4	Landscape Addendum 1	MGN	26JUN17
3	Issued for Tender	MGN	26MAY29
2	Issued for Permit	MGN	26MAY29
1	REV'd FOR COMMENT	MGN	26JAN16

Title:
LANDSCAPE PLAN

Project:
ONTARIO ABORIGINAL HOUSING SERVICES
321 JOHN STREET
COBOURG, ON

LANDSCAPE DETAILS

4 METAL FENCE

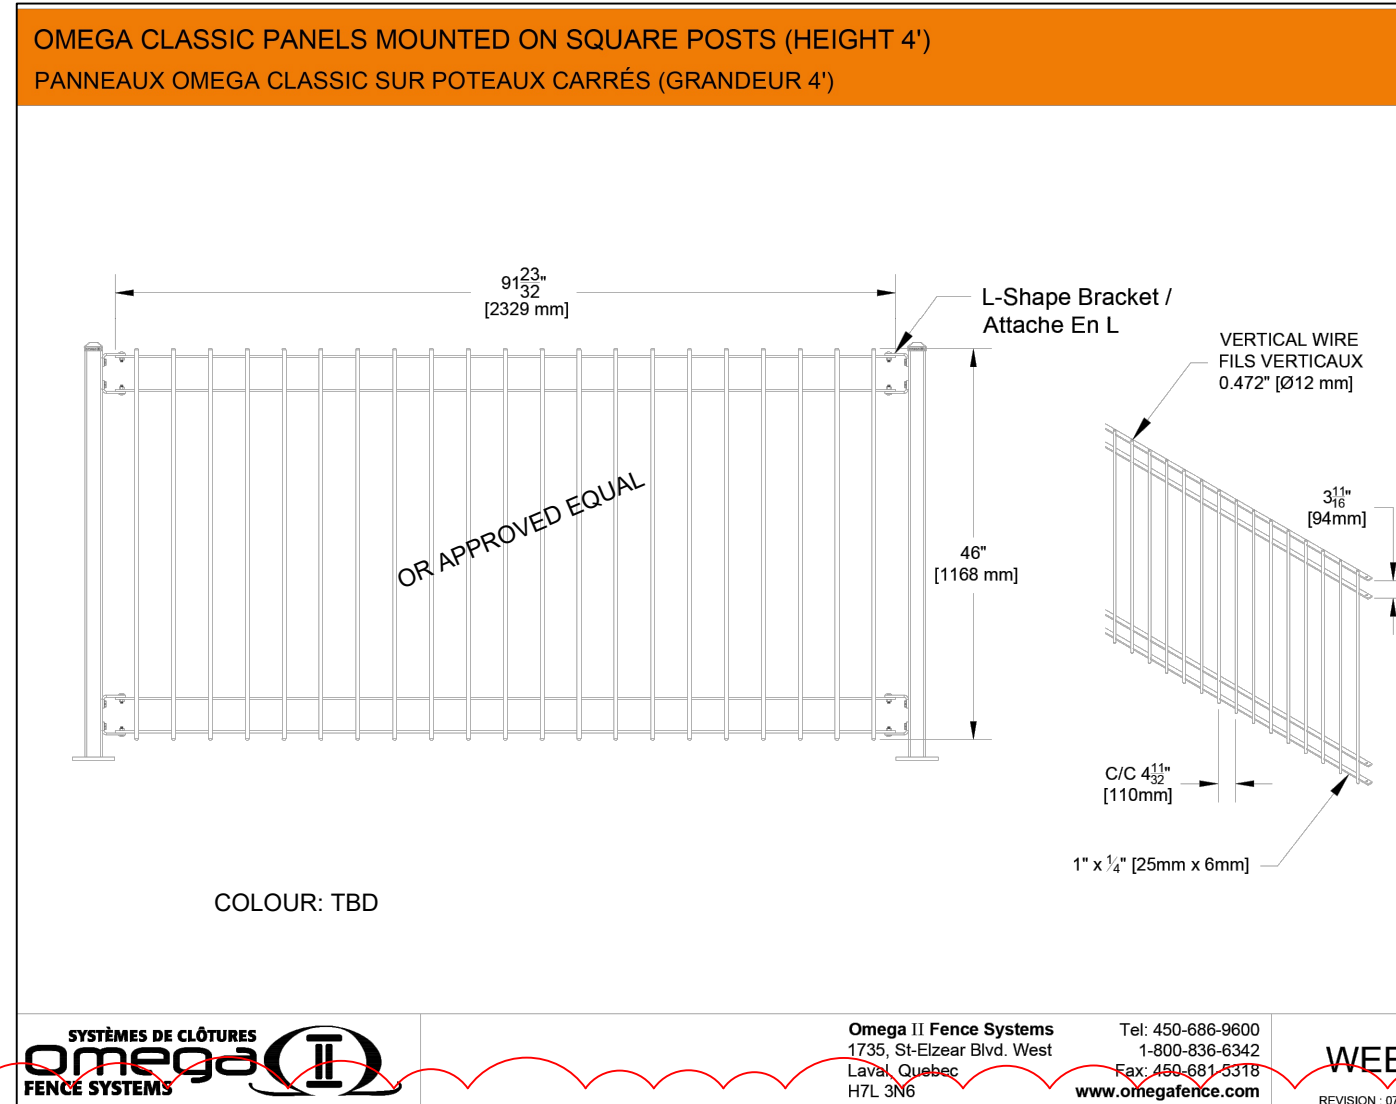
#4 Submit shop drawings for review prior to fabrication. Shop drawings shall include all dimensions, materials, connections, anchorage, finishes, and installation requirements.

2 PLANTER 2 - CIP CONCRETE

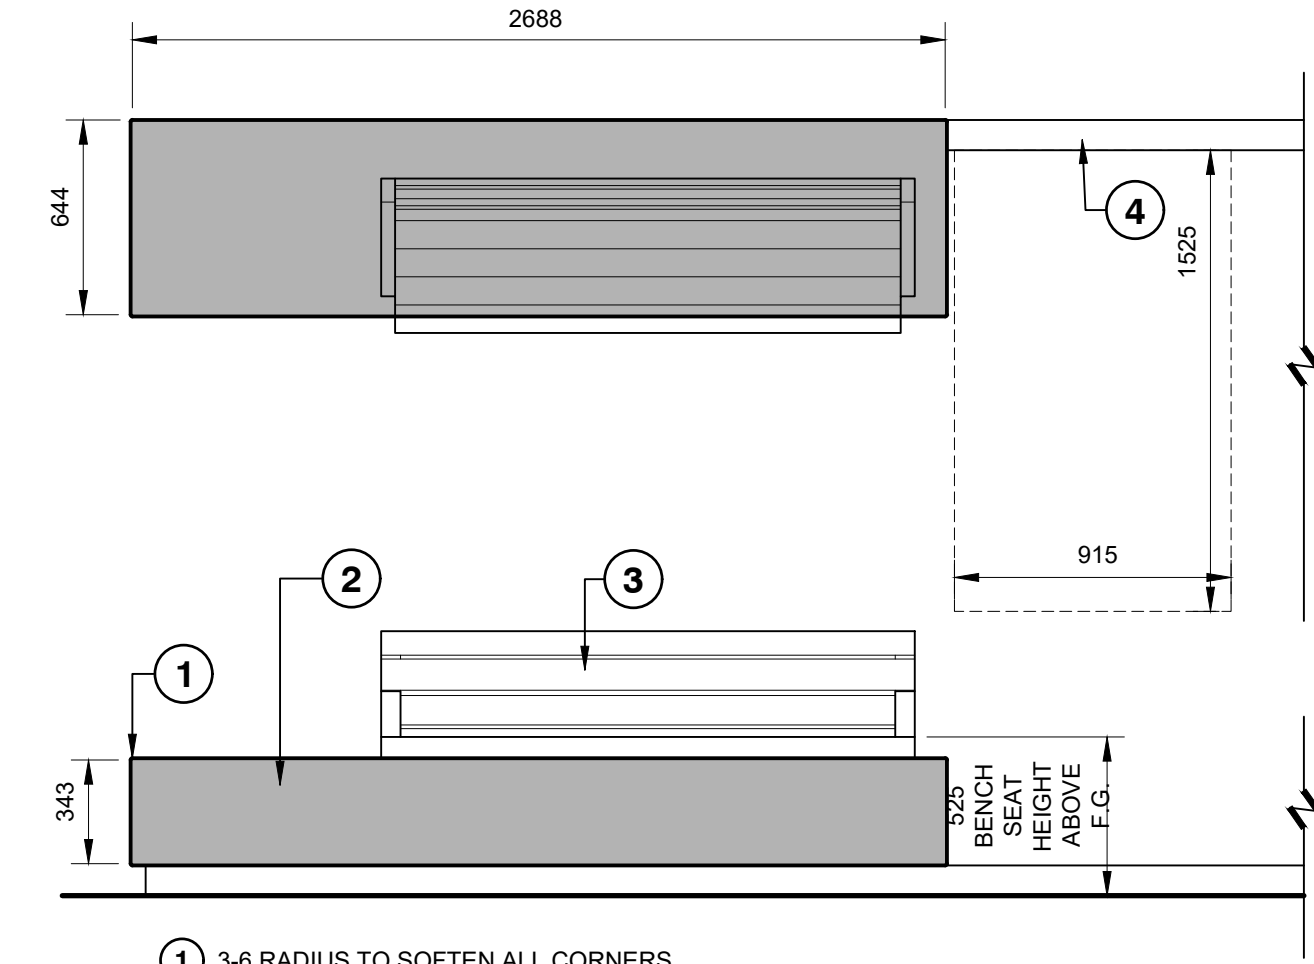
DELETE
REFER TO
STRUCTURAL
FOR EDGE OF
FLUSH PLANTING
BED

1 ENTRY STAIR AND RAMP
1:30

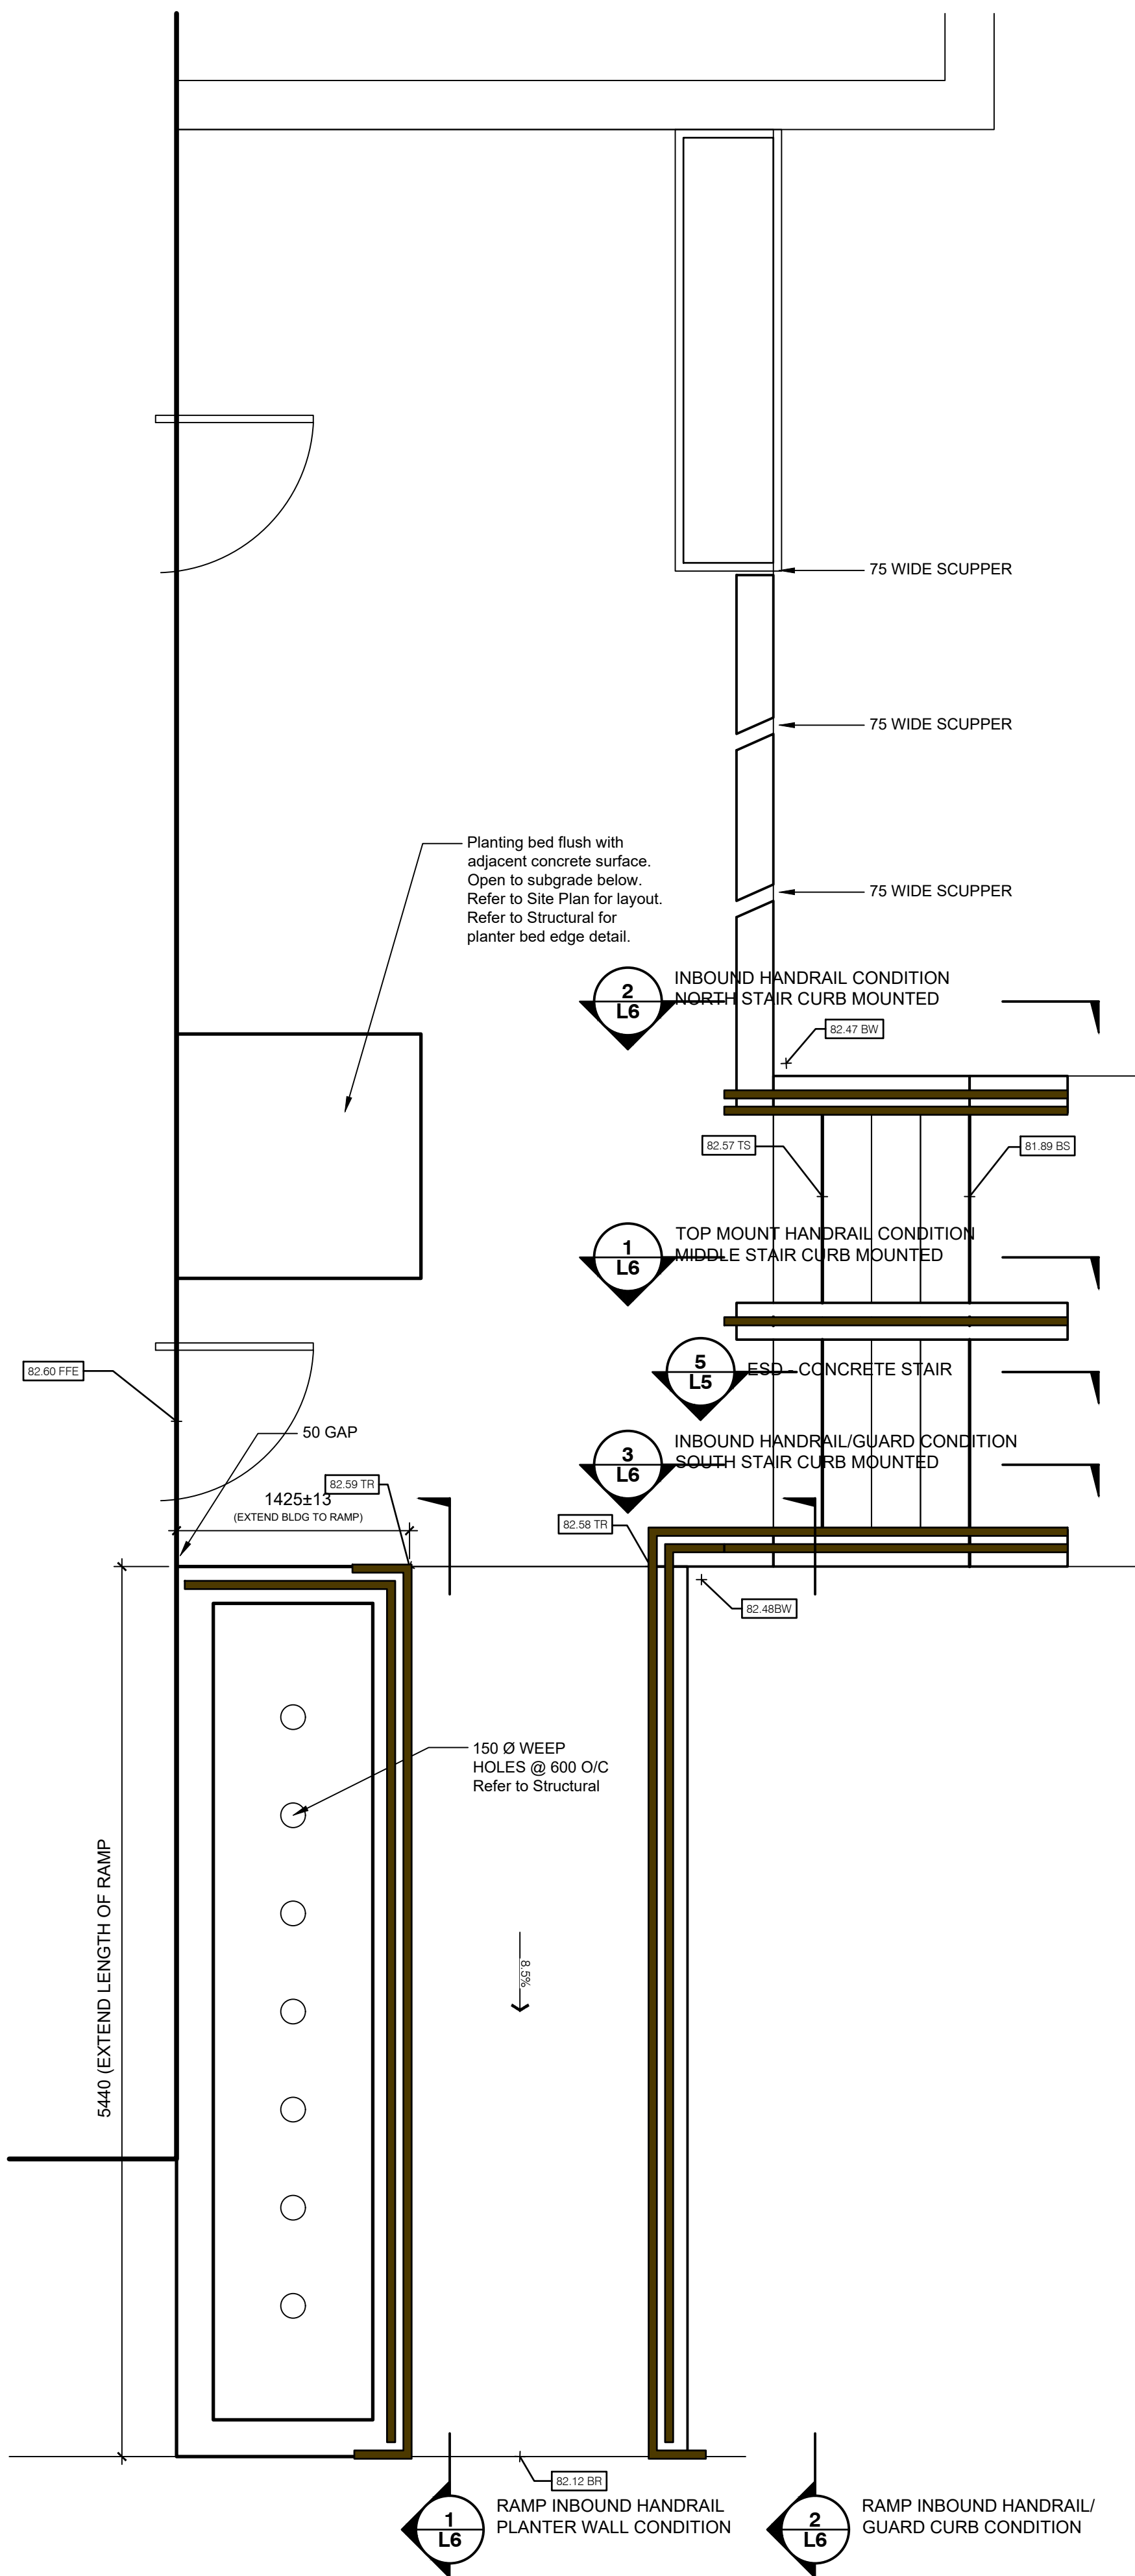
ALL DETAILS THIS SHEET:
Submit shop drawings, design calculations, and sealed drawings prepared by a Professional Engineer licensed in the Province of Ontario for review prior to fabrication. Shop drawings shall include all dimensions, materials, connections, anchorage, finishes, and installation requirements.
